PRODUCT UPDATE

HAULMAAX® EX Heavy-duty Rear Rubber Suspension

SUBJECT: Suspension Enhancements

LIT NO: SEU-0241

FIGURE 1

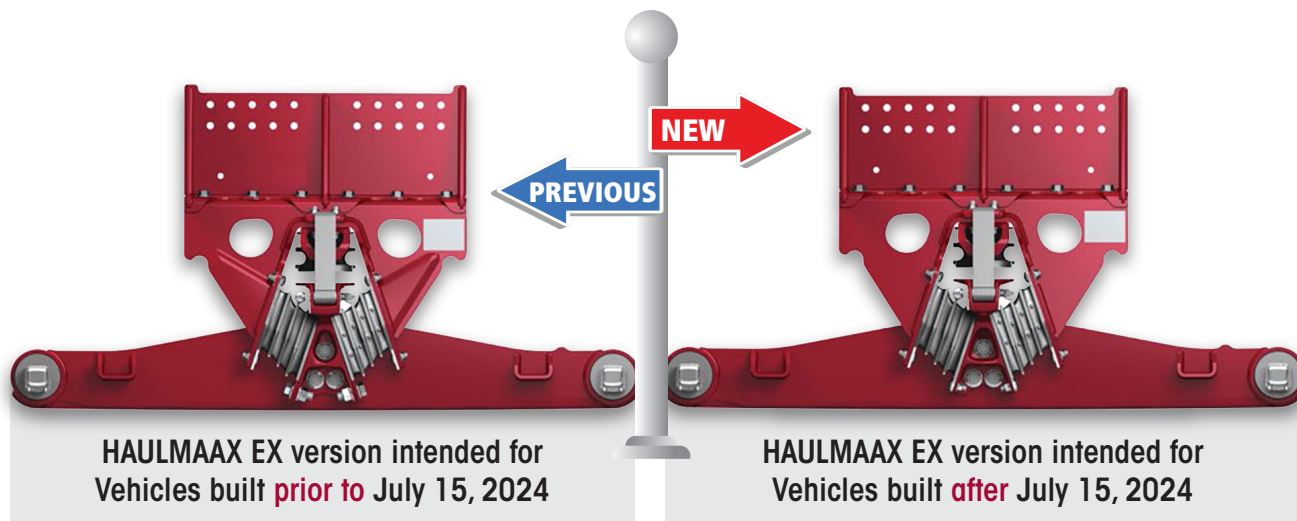
The following visual guidance (Figures 1 through 7) helps distinguish the respective versions of the HAULMAAX EX suspension system intended for installation on new vehicles manufactured before vs. those after July 15th, 2024. Additional information summarizes various aftermarket service kits that are available, on an as-needed basis, to facilitate updates to the most recent design improvements. Contact Hendrickson Truck Parts at 1.866.755.5968 (Toll-free U.S. and Canada), 630.910.2800 (Outside U.S. and Canada) or e-mail: truckparts@hendrickson-intl.com.

FIGURE 2

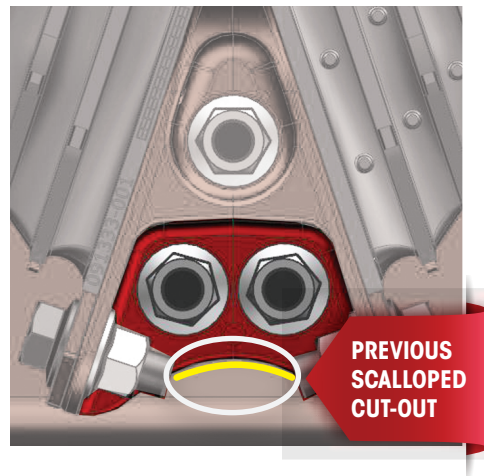
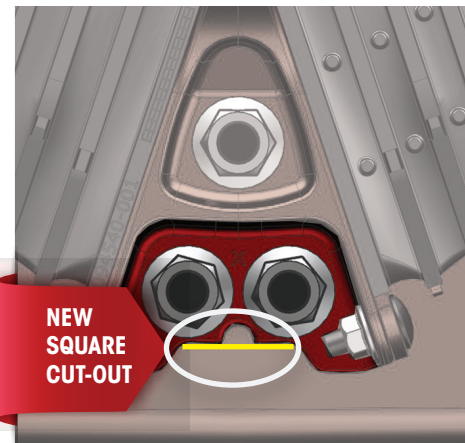
The prior HAULMAAX EX equalizing beam saddle featured a scalloped cut-out design, while the updated version has been re-designed with a square cut-out, see Figures 2 and 3. This modification standardizes the bolster spring fasteners.

FIGURE 4

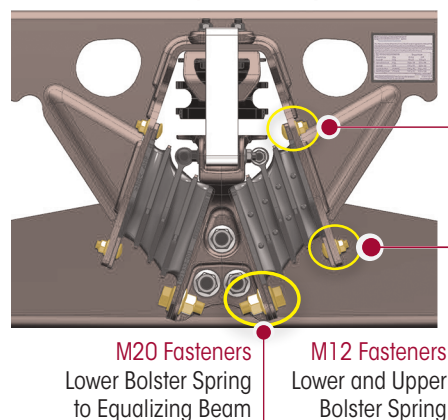
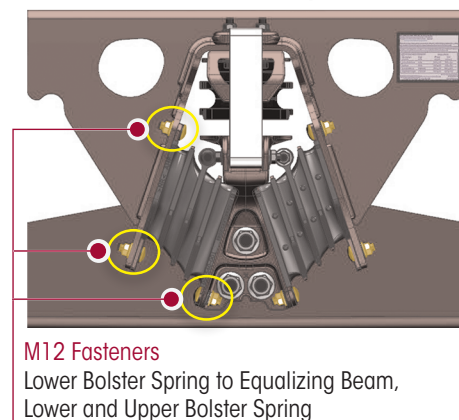
The prior HAULMAAX EX suspension system was equipped with M12 flange fasteners for the bolster spring upper flange and M20 flange fasteners for the bolster spring lower flange. The new version features M12 flange fasteners for both the bolster springs upper and lower flanges, achieving a more standardized design across these components, see Figures 4 and 5.

To upgrade from the prior version to the new one, use Service Kit numbers 34013-519 (40K lb. capacity) or 34013-522 (46K•52K lb. capacity), refer to included parts shown in this publication.

FIGURE 6

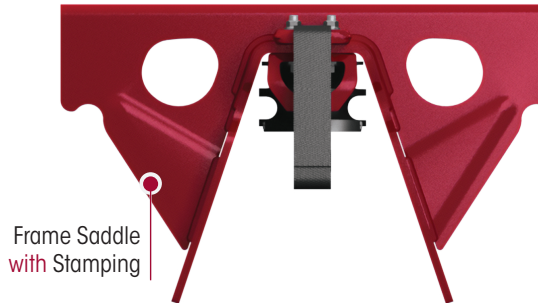
When comparing the prior and new versions of a frame saddle, the most notable difference is the absence of the frame saddle stamping in the new version, see Figure 6 and 7. This change reflects an update in design with more streamlined look.

Although the appearance of the frame saddle has undergone alterations, its functional features have remained consistent.
